**RESPONSE TO DEVELOPMENT TEAM REVIEW COMMENTS 2<sup>nd</sup> Review 5/11/2020**

**CASE NAME/NUMBER PRC-2019-00018**

**Development Services, Planning**

1 SITE PLAN  
1" = 20'-0"

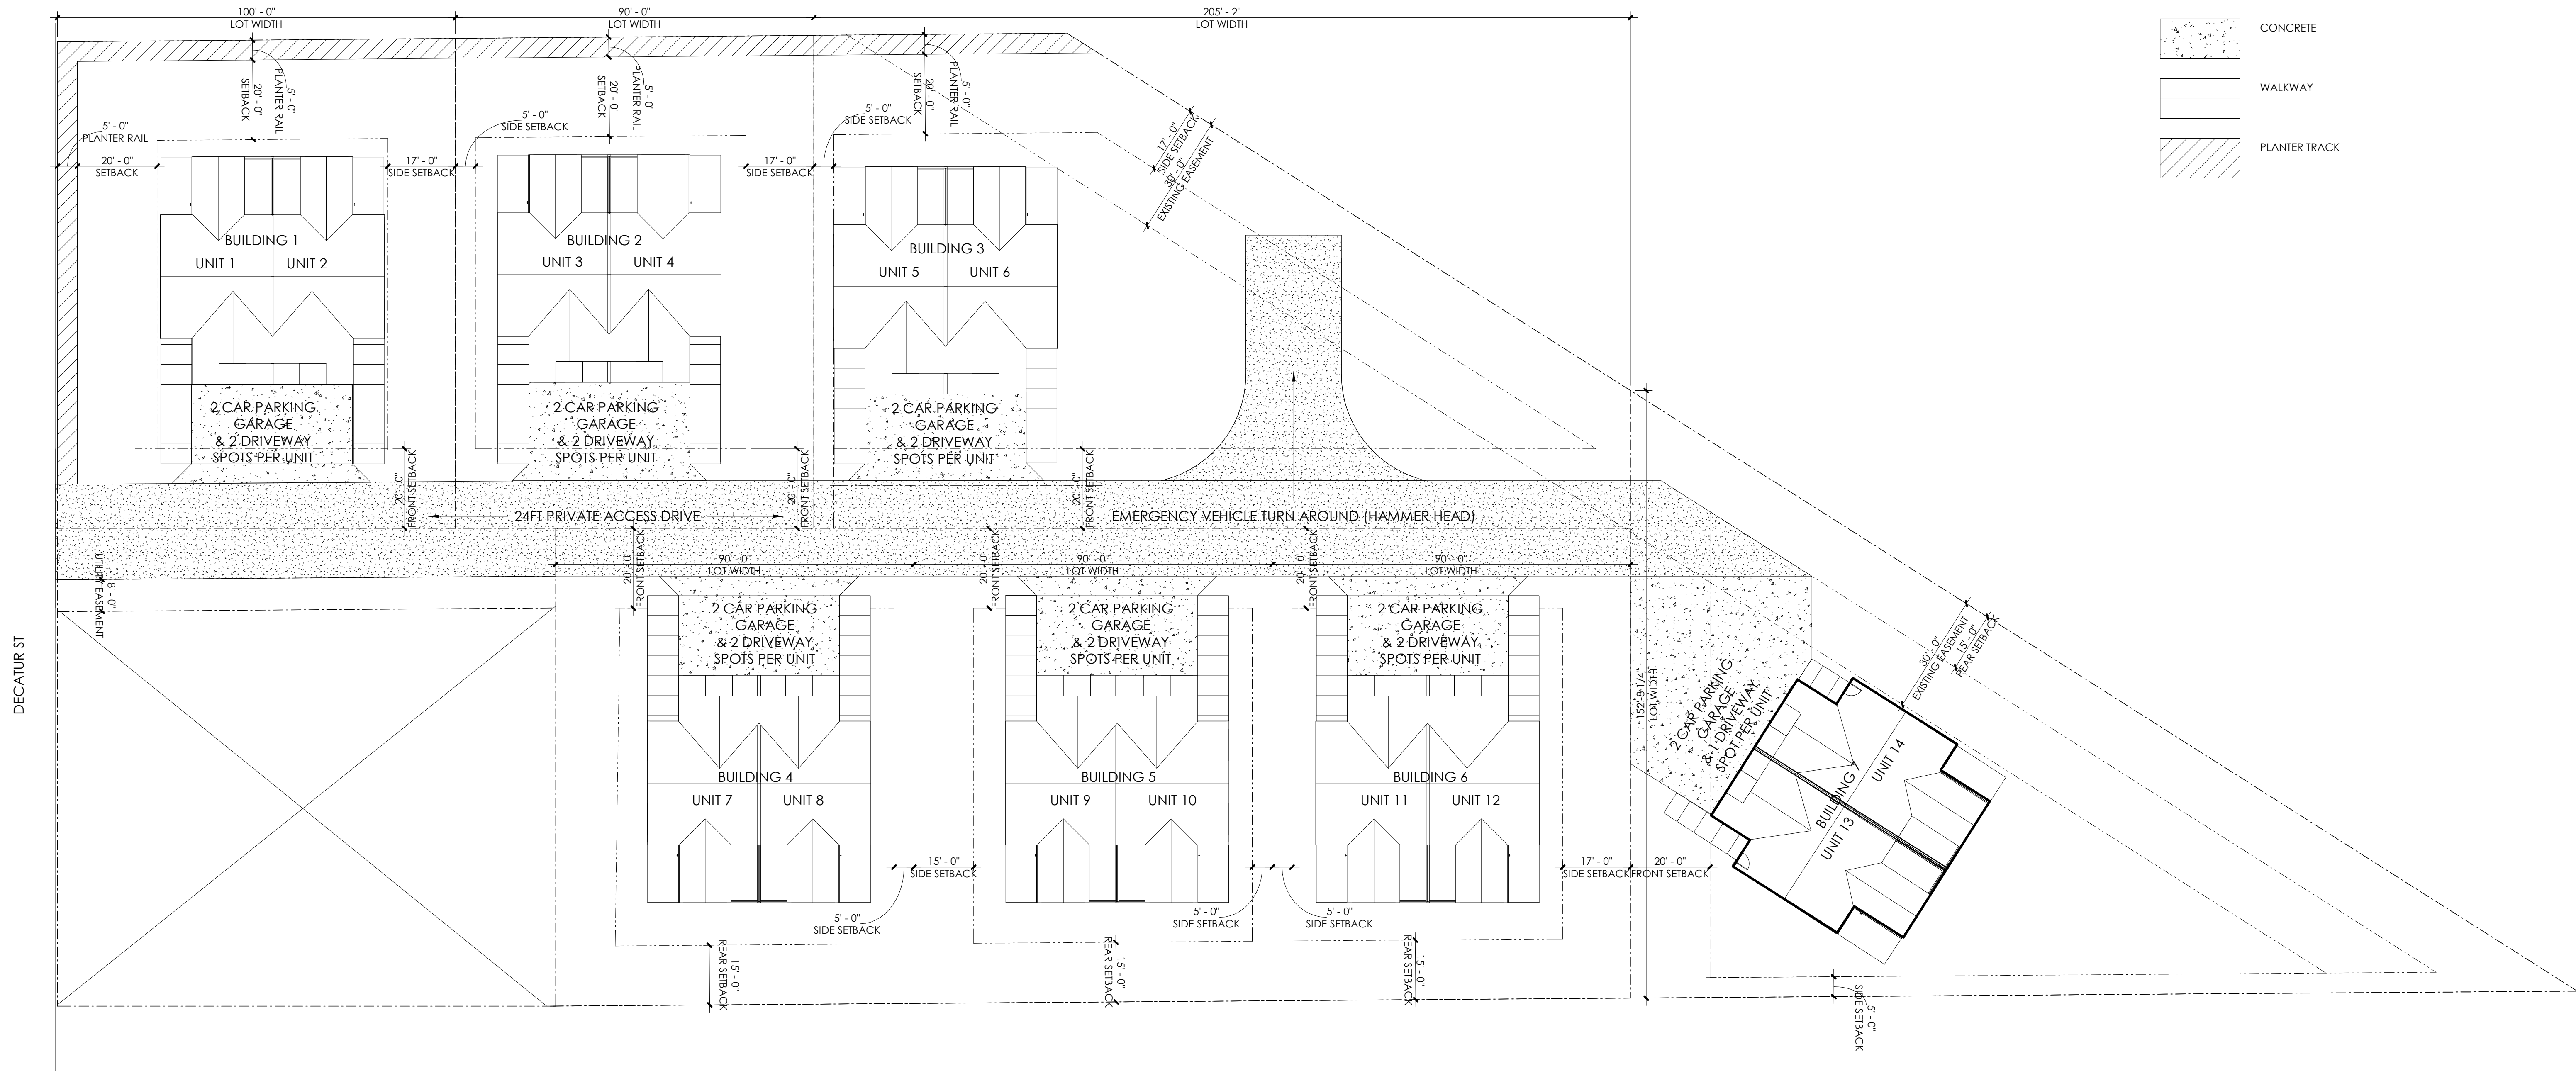
**PLN2:** As currently designed, the front property line for Lot 7 would be its west lot line. The lot width should be measured from the front setback line. It appears that Lot 7 can meet the minimum lot width requirement and that Building 7 could meet the required setbacks for a principal structure in the R-2 zone district, but the applicant must update their site plan in order to confirm that the required setbacks can be met.

**PLN3:** Staff believes that the irregular shape of Lot 7 may be a point of contention during public hearings. If the proposed density of this infill project becomes controversial, then this irregularly shaped lot may be viewed as a technique for adding an inappropriate amount of density to the site.

PLN4: Building 1 requires a side corner setback from the west lot line and from Decatur Street of 20'. Applicant must update site plan in order to show that this setback can be met. The required side setback for a principal structure with an attached garage from the east lot line is 5'. Corrected setback shows on new site plan.

PLN5: Section 5-03-03-08-01 from the County's Subdivision Design Standards discourages the creation of double-frontage lots. As currently shown, Lots 2 and 3 are double frontage lots, and Lot 1 has three frontages.

Applicant must clarify if they are proposing a two car parking garage and one driveway parking space per dwelling unit for a total of three parking spaces per dwelling unit, or if they are providing a one car parking garage and one driveway parking space per dwelling unit for a total of two parking spaces per dwelling

- a. The west property line of Lot 7 would be considered as the front property line, which requires a 20' setback for principal structures.  
**RESPONSE: Site Plan revised Lot 7 now has 20' west property line setback.**
- b. The south property line of Lot 7 would be considered as the side property line, which requires a 5' setback for principal structures with attached garages.  
**RESPONSE: Site Plan revised to show 5' setback.**
- c. The northeast property line of Lot 7 would be considered as the rear property line, which requires a 15' setback for principal structures (from the property line, not from the easement area). **RESPONSE: Revised to show 15' rear setback.**

- a. Staff recommends extending the west lot line of Lot 7 north in order to connect to the northeast property line. Such a reconfiguration would create a perfect triangle for Lot 7.  
**RESPONSE: Revised the shape of Lot 7 has been modified. New Preliminary Plat attached showing changes.**
- b. The remaining area that was previously included as part of Lot 7 (north of the private road) could then be incorporated into Lot 3 or designated on the Preliminary Plat as a commonly maintained Tract.  
**RESPONSE: Revised the shape of Lot 7 has been modified. New Preliminary Plat attached showing changes.**

***RESPONSE: Site Plan revised to show 20' setback from west property line and adjusted to show 5' setback on east lot line.***

***RESPONSE: New preliminary plan attached shows parking for two-car attached per unit and two car parking per unit on each driveway. 4 total per unit***

A REPLAT OF LOT 1, LYNN PETERSON SUBDIVISION, A RESUBDIVISION OF LOT 10, BLOCK 4, NORTH FEDERAL HILLS

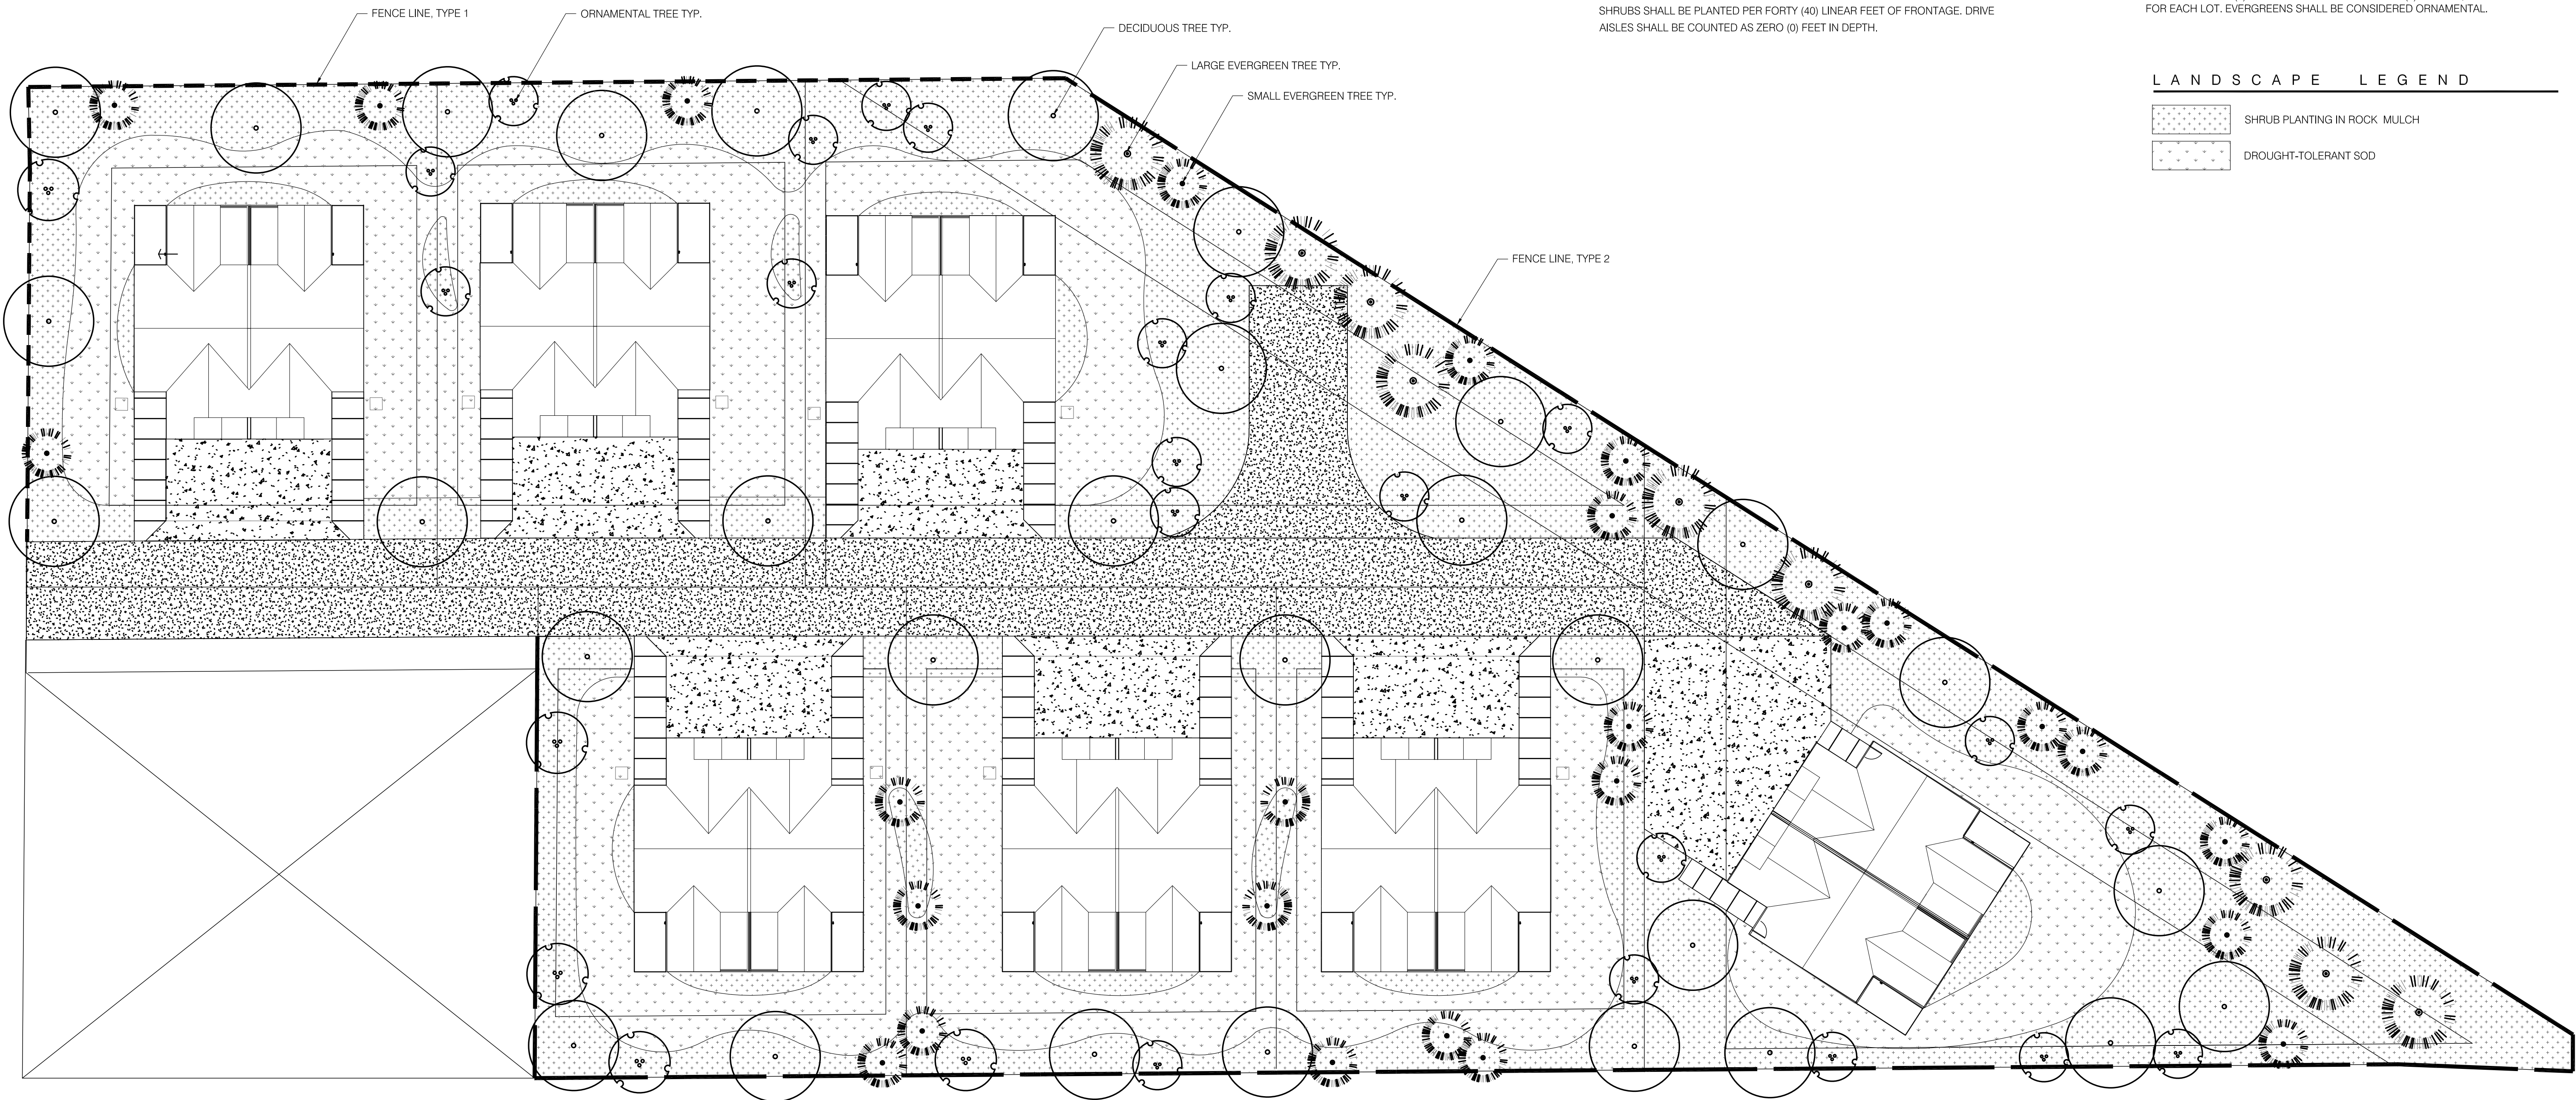
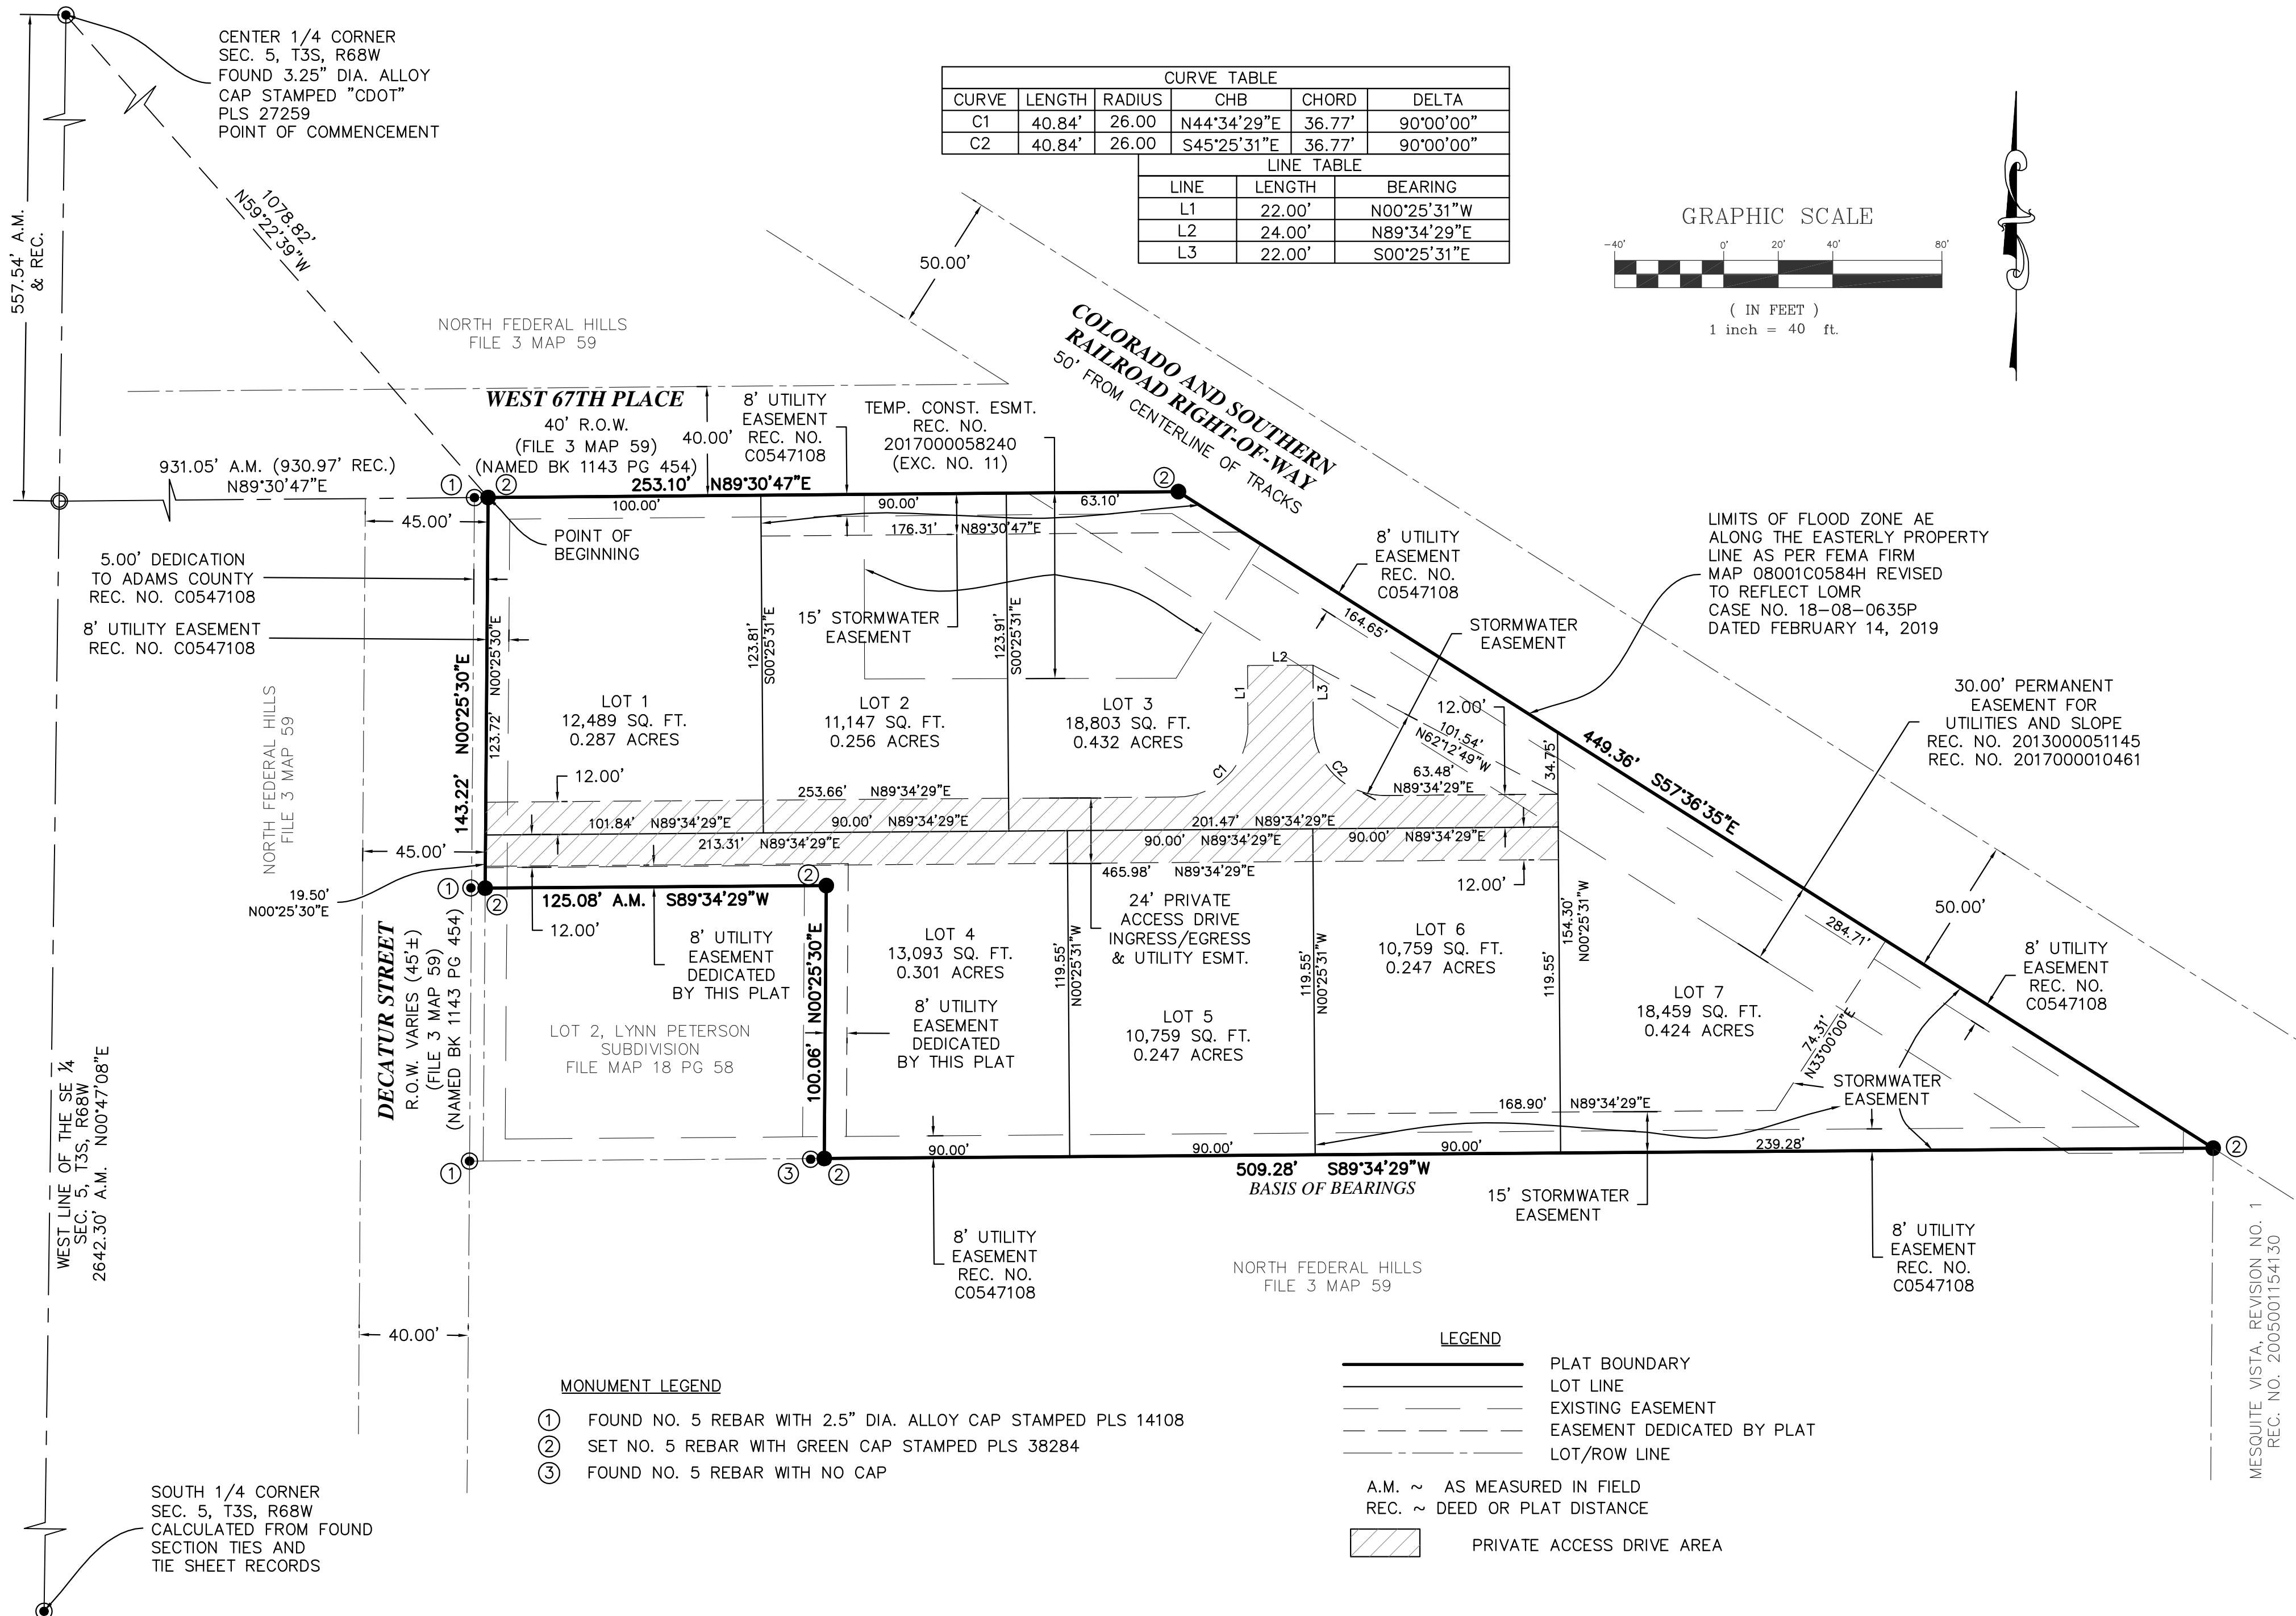
Applicant must explain why the proposed private road is shown as connecting to the railroad right-of-way along the east property line. Would this proposal enable someone to drive directly onto the railroad right-of-way?

ENG1: Although this is a preliminary plat, it appears that a preliminary drainage analysis was not completed because the plat does not show an easement for a water quality pond and/or detention pond that are typically required with the development of a subdivision. The applicant must provide documentation on why a water quality/detention pond is not required for this subdivision or they need to show an easement for the drainage facility on the preliminary plat.

ROW1: Utility and access easements shall also be granted within any private streets in the subdivision. Said easements shall be clearly labeled to include width, use, and identification as public or private, if necessary. Clearly show and label all existing easements, to include width and recording information, that cross, abut, or are located within the subdivision boundary.

ROW2: Basis of Bearing and Point of Commencement must be labeled on plat drawing.

ROW3: Existing street rights-of-way that intersect the subdivision boundary or are adjacent to said boundary lines shall be clearly labeled with the street name, right-of-way width, and appropriate deed or plat recording information wherein the right-of-way is defined.

ROW4: “Existing easement” and “lot/row line” labels must be differentiated on plat drawing. Please update legend and provide different line weights in order to better differentiate the two labels.

ROW5: There appears to be one easement included in Schedule B (Part 2) of the submitted Title Commitment that is not shown on the Plat Drawing. Item #10 has a recording date of March 12, 2013, and a reception number of 2013000021210. If the location of any of the easements defined within the Schedule B – Part 2 Exceptions of the Title Commitment are not shown on the plat, please provide a statement or general note as to why (i.e. Exception 10 – Rec No: 2013000021210).

***RESPONSE: Revised New Preliminary Plat attached showing changes to road. Private road easement has been modified to stop short of the railroad right-of-way.***

***RESPONSE: New preliminary plat will show drainage.***

***RESPONSE: Utility, Ingress/Egress Easements are now shown within the private street/drive. The entire drive will be for above said purpose. All existing easements and widths are/have been shown on the plat.***

***RESPONSE: The basis of bearings, point of commencement and point of beginning are/have been shown on the plat. Please let us know if you can't find this information and we will point it out.***

***RESPONSE: Existing streets and ROW are shown. File and Map information has been added for the streets. The 5' ROW strip along Decatur is/has been shown with recording information.***

***RESPONSE: The line types have been changed to make these clearer.***

***RESPONSE: Exception No. 10 of the title commitment cannot be plotted. There is no specific location for this easement (court ordered easement). There is no visible communication equipment (Pedestal's, Vaults, Manholes, Buildings, etc.) along the RR ROW. However, this easement does grant access to/from the RR ROW for the telecom's to maintain/install their equipment. This easement shows up on any property in Colorado that abuts the main RR ROW but there are no specific locations of the easement provided. If this easement is an issue, then it must be resolved between the owner and telecom and/or Adams County. I am positive that this is not the first time that the county has seen this specific easement on property that abuts the RR ROW.***
